UNITED STATES PATENT AND TRADEMARK OFFICE

APPLICATION NO.	FILING DATE	FIRST NAMED INVENTOR	ATTORNEY DOCKET NO.	CONFIRMATION NO.
10/796,584	03/08/2004	Clark R. Baker JR.	TYHC:0149/FLE (P0409R)	1106
52144	7590	11/25/2005	EXAMINER	
FLETCHER YODER (TYCO INTERNATIONAL, LTD.) P.O. BOX 692289 HOUSTON, TX 77269-2289			RAMIREZ, JOHN FERNANDO	
			ART UNIT	PAPER NUMBER
			3737

Office Action Summary	Application No. 10/796,584	Applicant(s) BAKER, CLARK R.	
	Examiner John F. Ramirez	Art Unit 3737

DETAILED ACTION

FIG. 25B

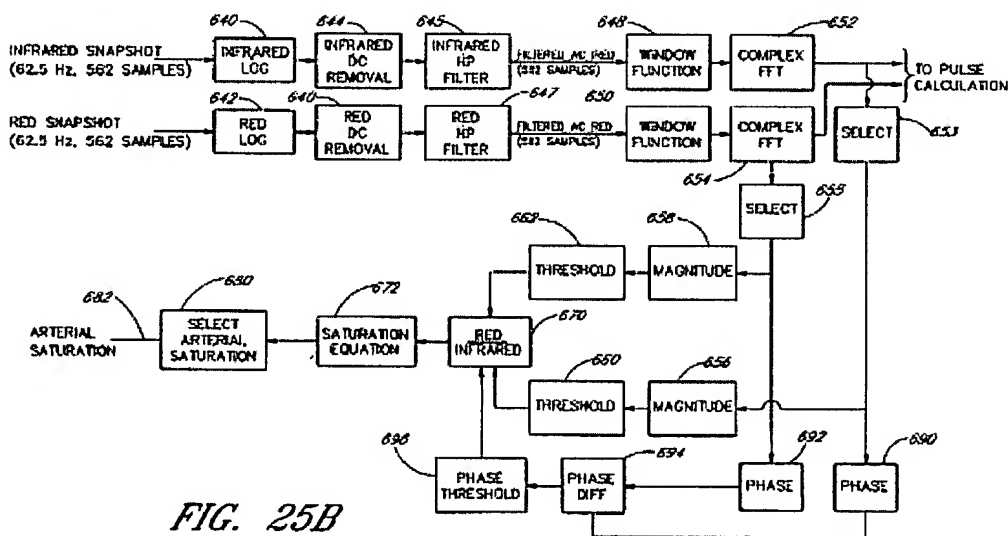
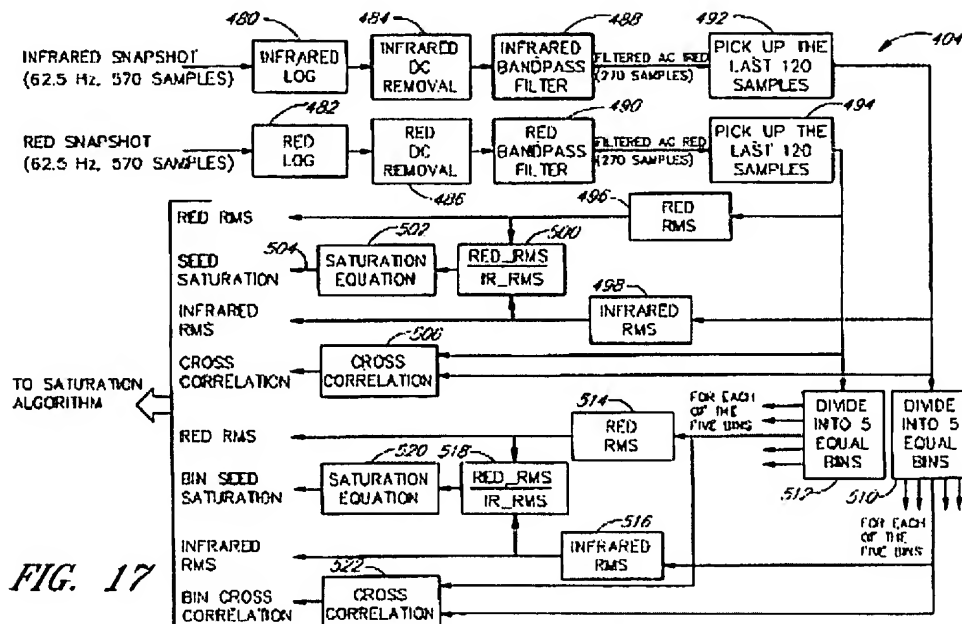
With respect to claims 1-4, 7, 8, 13-16, 19 and 20, Diab et al. discloses a method of detecting the presence of mixed venous and arterial blood pulsation in tissue, comprising: receiving first and second electromagnetic radiation signals from a blood

perfused tissue portion corresponding to infrared and red wavelengths of light, (abstract), obtaining a measure of a phase difference between said first and second electromagnetic radiation signals (Figure 25B), comparing said measure with a threshold value to form a comparison; and detecting the presence or absence of venous pulsation using said comparison (col. 31, paragraph [0387] – col. 32, paragraph [0395]), filtering said first and second electromagnetic radiation signals before said obtaining said measure, to pass portions of said first and second electromagnetic radiation signals having frequencies at or near the pulse rate or harmonics of the pulse rate of said blood perfused tissue (645, 647, Figure 25B), obtaining a measure of a phase difference between said first and second electromagnetic radiation signals comprises obtaining a measure of a persistent phase difference between said first and second electromagnetic radiation signals (694, Figure 25B), obtaining a measure of a persistent phase difference comprises integrating said measure of a phase difference over a time period (col. 10, paragraph [0133]), obtaining a measure of a phase difference comprises a frequency domain analysis and subtracting the phases of said first and second electromagnetic radiation signals at a frequency (col. 32, paragraph [0402]), subtracting the phases of said first and second electromagnetic radiation signals comprises taking the complex conjugate of said first and second electromagnetic radiation signals, and dividing said complex conjugate by the product of the magnitudes of said first and second electromagnetic radiation signals (652, 654, 656, 658, Figure 25B).
